UNITED STATES PATENT AND TRADEMARK OFFICE

APPLICATION NO.	FILING DATE	FIRST NAMED INVENTOR	ATTORNEY DOCKET NO.	CONFIRMATION NO.
09/960,172	09/21/2001	Chun-Hsiang Chiang	A1-082 US	4260
23683	7590	12/02/2003	EXAMINER	
MOLEX INCORPORATED 2222 WELLINGTON COURT LISLE, IL 60532			LEON, EDWIN A	
			ART UNIT	PAPER NUMBER
			2833

DETAILED ACTION

Attachment 1

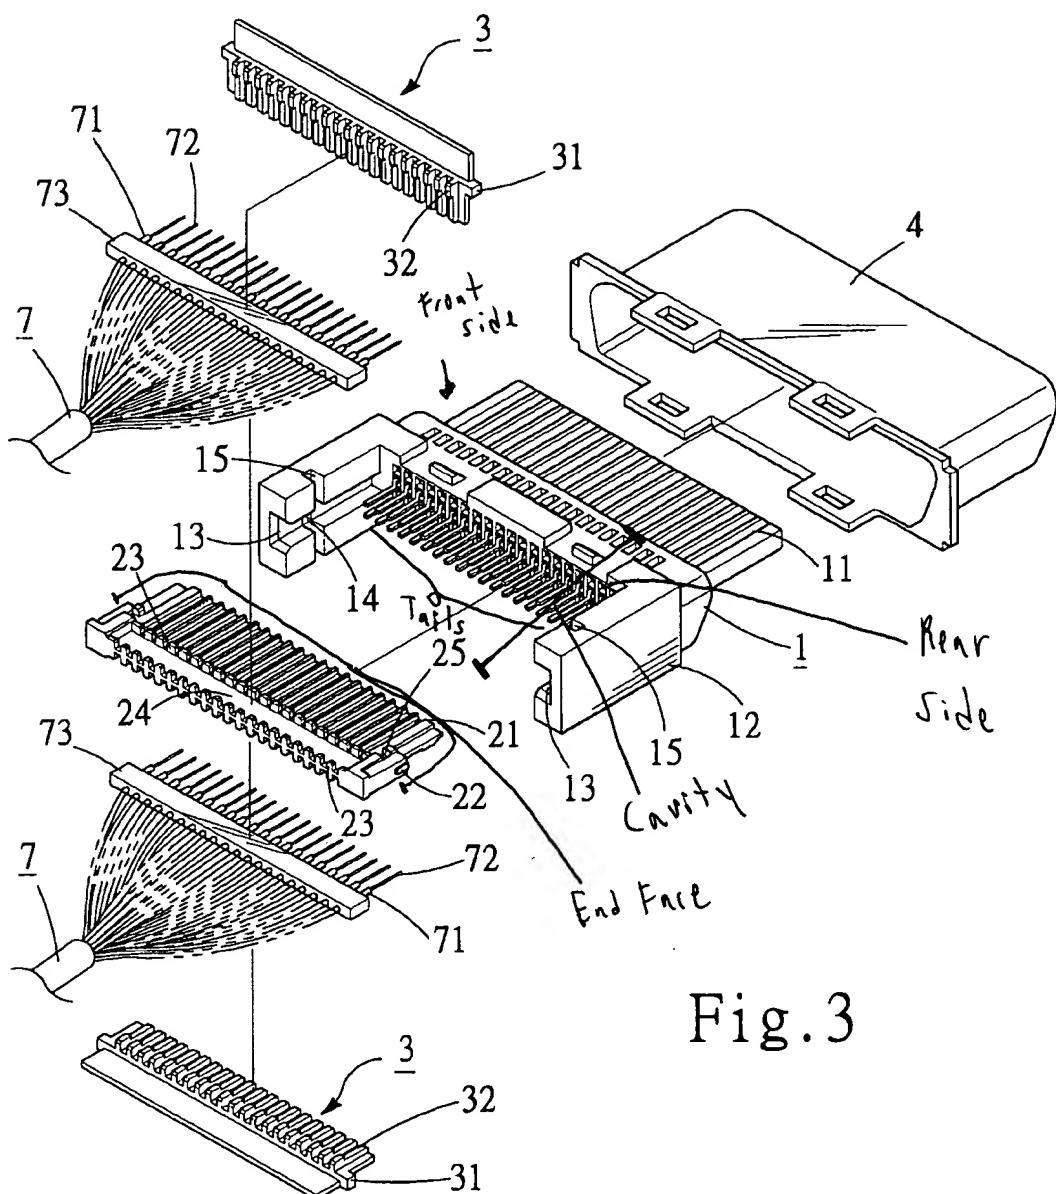
4. Claims 1-15 and 17-21 are rejected under 35 U.S.C. 102(b) as being anticipated by Yang (U.S. Patent No. 6,039,611). With regard to Claims 1 and 21, Yang discloses an electrical connector for use with an electrical cable (7) having a plurality of wires (71), the electrical connector comprising: a connector body (1), the connector body (1) comprising a front side, a rear side, a cavity between the front and rear sides, a plurality of terminal passageways (where 11 is disposed), and a plurality of terminals (11) respectively received within the terminal passageways (where 11 is disposed), the terminals (11) each having a tail (Fig. 3) extending out of the rear side of the connector body (1); and a wire management member (2,3), the wire management member (2,3) including a body portion (2) having an end face, the body portion (2) adapted to support the tail (Fig. 3) of each of the terminals (11) and at least one wire groove (21) for receiving on of the plurality of wires (71), the wire management member (2,3) comprising a projection rod (22) projecting from an end face of the body portion (2), the projection rod (22) being received within the connector body cavity. See Figs. 3-6 and Attachment 1.

With regard to Claim 2, Yang discloses the wire management member body portion (2) including a plurality of terminal grooves (21), the terminal grooves (21) being adapted to receive the tail (Fig. 3) of each of the terminals (11). See Figs. 3-6 and Attachment 1.

With regard to Claim 3, Yang discloses the wire management member body portion (2) including a plurality of wire grooves (21), the wire grooves (21) adapted to receive the wires (71) of the cable for enabling the wires (71) of the cable (7) to be respectively electrically soldered to the tail (Fig. 3) of each of the terminals (11). See Figs. 3-6 and Attachment 1.

With regard to Claim 5, Yang discloses the wire management member (2,3) comprising a plurality of ribs (23) respectively disposed between two adjacent terminal grooves (21) above the elevation of the tail (Fig. 3) of the terminals (11). See Figs. 3-6 and Attachment 1.

With regard to Claim 20, Yang discloses at least one of the platforms (23) comprising a plurality of wire grooves (21) adapted to receive the wires (71) of the cable. See Figs. 3.
